EPA - New England

Clean Water Act NPDES Permitting Determinations for the Thermal Discharge and Cooling Water Intake Structures at Merrimack Station in Bow, New Hampshire

NPDES Permit No. NH 0001465

Figure 5-1 Scatterplot and best fit line of changes in combined electrofishing CPUE for all species collected in 1972 within ambient and thermally-influenced zones of Hooksett Pool, and pool-wide. Sampling conducted in 1972 – 1974, 1976, 1995, 2004, and 2005

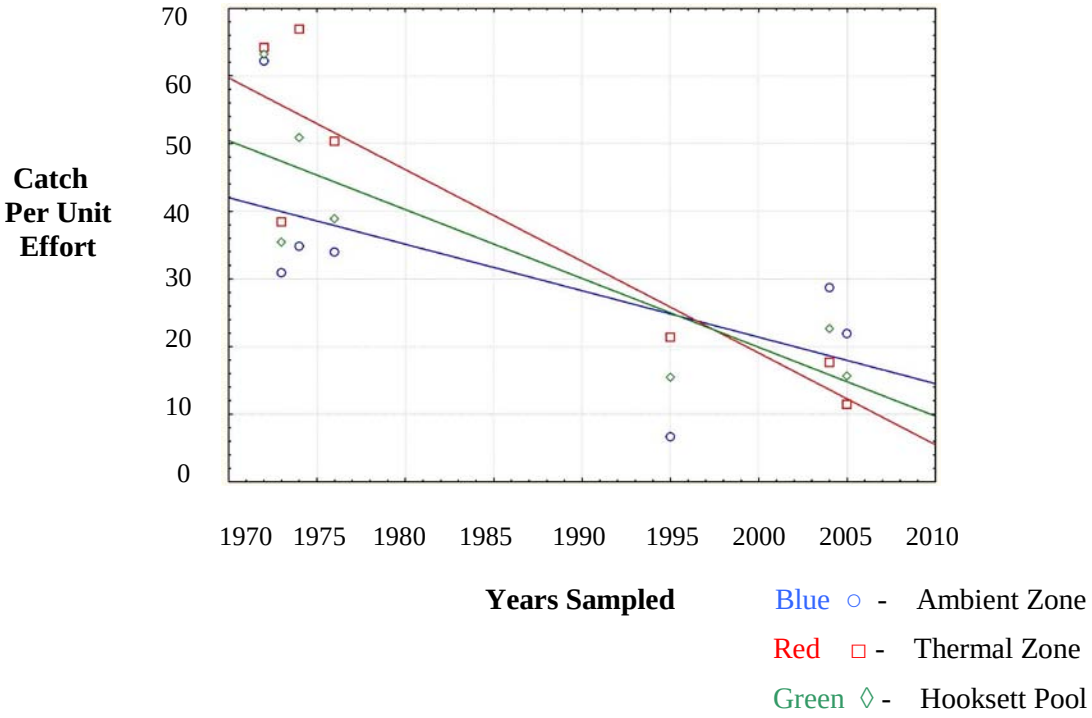
The plant's conclusions were likely influenced by the presence and abundance of two species, bluegill and spottail shiner, which were not captured in Hooksett Pool in the 1960s and early 1970s. These species, and others that appeared later, should not have been included in an analysis of the balanced, indigenous community, except to explain how their presence may have affected the indigenous community. Therefore, EPA finds Merrimack Station's conclusion of "no appreciable harm" in this analysis to be unsupported by the data, as it applies to the balanced, indigenous community.

Figure 5-2 Comparison of total trapnet CPUE between 1970s and 2000s for all species identified as being part of the BIP in the 1960s, based on data provided in Table 3-17 of the Fisheries Analysis Report (Normandeau 2007a)

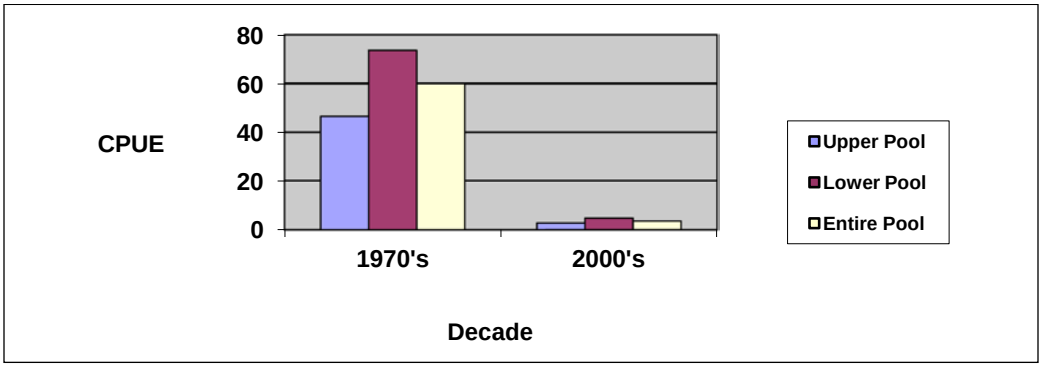
Merrimack Station decided it could not complete a trends analysis for trapnet data similar to what it did for electrofish sampling. As described above, the facility decided it could not use a good deal of the trapnet data it had collected over the years in a trends analysis. Merrimack Station did, however, compile the data sets that it considered useable from the 1970s and the 2000s to provide a "then and now" analysis of changes in CPUE. This assessment by the facility concludes that trapnet CPUE is significantly lower in the 2000s than it was in the 1970s (Figure 5-2).

Specifically, using the data selected by Merrimack Station, CPUE for all species combined dropped by 89 percent between the 1970s and 2000s. Declines in the lower, or thermally-influenced, section of Hooksett Pool were even greater, dropping 91 percent. These data also provide a comparison of habitat use between both areas and decades. In the 1970s, the CPUE in the lower Hooksett Pool was 63 percent greater than in the upper Hooksett Pool. By the 2000s, however, they were both similarly depressed (Table 5-8).

Figure 5-8 Changes in the Hooksett Pool fish community based on electrofishing sampling conducted in the 1960s, 1970s, 1990s and 2000s

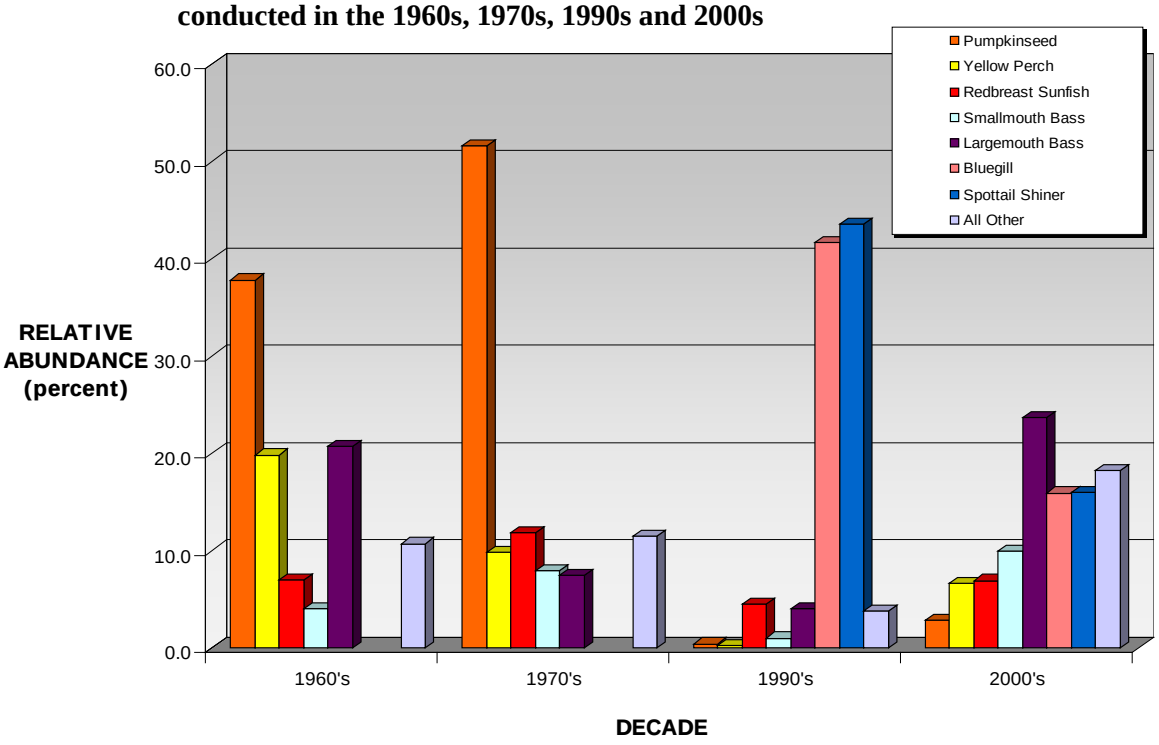
ambient zone during sampling conducted in 1995 and the 2000s supports a finding of "no appreciable harm." Yet, this argument fails to address impacts to the balanced, indigenous community since the balanced, indigenous community is most closely represented in this analysis by the 1970s fish community. It is obvious from the sampling data that significant adverse impacts to the Hooksett Pool's balanced, indigenous fish community had already occurred by 1995 (Figure 5-8).

EPA disagrees with Merrimack Station's contention that this evidence suggests that "other factors" have caused changes in the community structure of Hooksett Pool fish community. While other factors, such as interspecies competition, may have contributed to changes in community structure, thermal impacts to the "thermally-influenced portion" of the pool likely affect the entire fish community of the pool. Studies have documented the importance of temperature-mediated competition on certain riverine fishes with results suggesting that the presence of competitively superior species may restrict the distributions of other species to thermally suboptimal habitats (Wehrly et al. 2003). Data from 1995, 2004, and 2005 show that bluegill, largemouth bass, smallmouth bass, and redbreast sunfish maintain numerical dominance in Hooksett Pool from 1995 to 2005 in the thermally-influenced zone. These species, all members of the sunfish family, have a comparatively high tolerance to heat. The greater similarity between 1995 and the 2000s in the thermally-influenced zone versus the ambient zone suggests to EPA that the most heat tolerant species are likely to remain numerically dominant in the thermally-influenced zone, and generally to fare better throughout Hooksett Pool than less

heat-tolerant species. As heat is a regulated pollutant, and the focus of this 316(a) variance request, EPA considers the dominance of heat-tolerant species in Hooksett Pool to be indicative of appreciable harm to the balanced, indigenous community.

Figure 5-9 Changes in the Hooksett Pool fish community based on trapnet sampling in the 1960s, 1970s, and 2000s

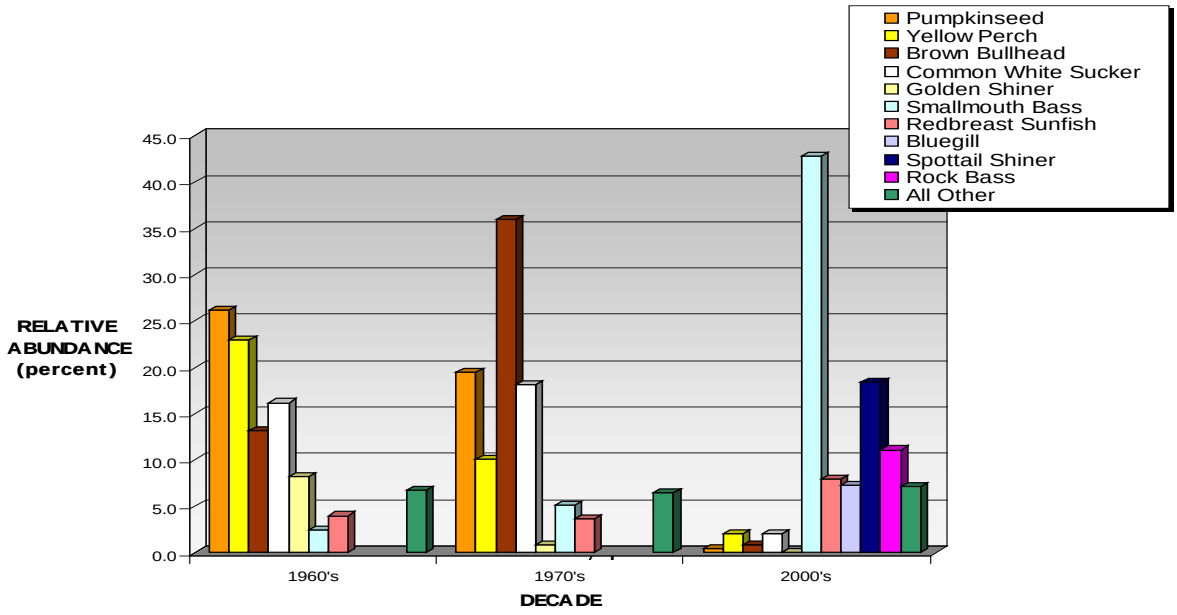
Merrimack Station argues that percent similarities between the fish community sampled during the 2000s are slightly greater for the lower Hooksett Pool than that found in the upper Hooksett Pool. This suggests that, according to Merrimack Station, factors other than potential thermal effects from the discharge of Merrimack Station (which the Station argues would be limited to the lower Hooksett Pool) have caused changes in the community structure of Hooksett Pool. Merrimack Station suggests that changes to the overall Hooksett Pool fish community can be best explained by the anthropogenic introduction of three centrarchid species, particularly bluegill, and are unrelated to Merrimack Station's thermal discharge.

EPA finds Merrimack Station's explanation for a nearly 77-percent change in the balanced, indigenous community since the 1970s unpersuasive and unsupported. Fish species in Hooksett Pool utilize the entire pool. The heated discharge from Merrimack Station has a capacity to directly affect approximately half of the available habitat in Hooksett Pool. As such, impacts to a particular species south of the discharge are likely to affect the entire pool-wide population.
